From: andy luhn <andyluhn@gmail.com>
Sent: Monday, June 12, 2023 10:37 AM
To: Participate <participate@ketchumidaho.org>; Matt Luhn <deepestpow@gmail.com>
Subject: Miller Residence Overlay Review 6/13

These are comments/questions we have for tomorrow's meeting on the Miller Residence/Mountain Overlay Review.

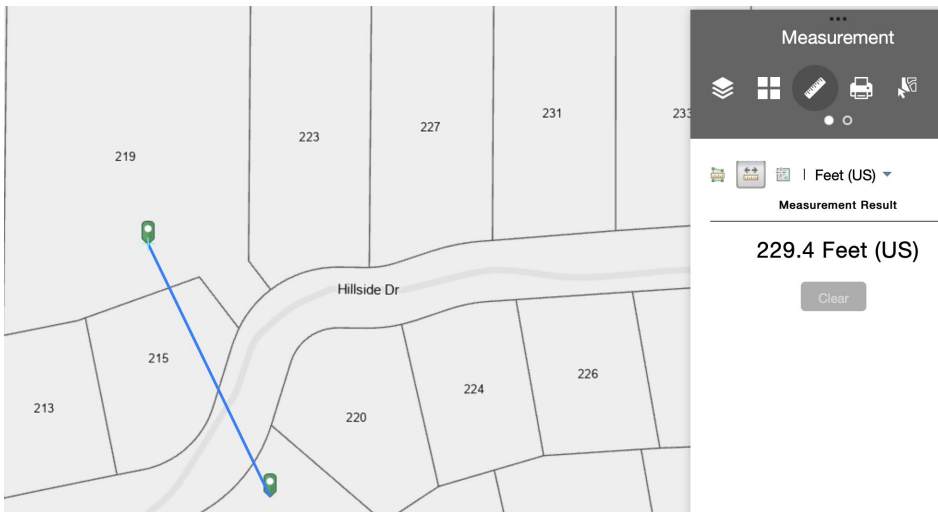
Our property line is +/- **90ft** away from From Millers:

I have read 172 pages of the Agenda packet. None of the engineering & survey reports, nor the avalanche research specifically addresses or includes the impact this project will have on our property and our adjoining neighbors. Our properties aren't included in any maps or sketches as well. Again, we are 90ft away.

Regarding avalanche risk 213 (Glenn) and 215 (Moss) are sadly natural barricades that would help block debris. Putting a house just above them is like putting in a Nordic Jump that would potentially launch debris over 213/215 and put the landing zone right in the middle of of our living room.
